# UNITED STATES PATENT AND TRADEMARK OFFICE

**Advisory Action  
Before the Filing of an Appeal Brief**

09/760,593

ISHII ET AL.

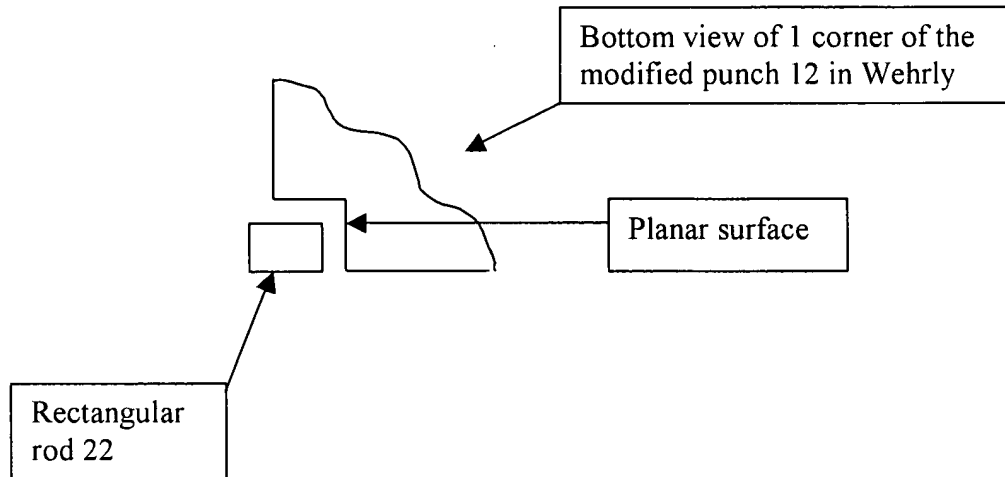
Applicant argues that the modified alignment system of Wehrly et al. does not meet the limitations of the claims since the alignment rods contact the punch at a corner edge, not on a planar surface. Examiner respectfully disagrees. The alignment rods contact the punch at a planar. See the below sketch.
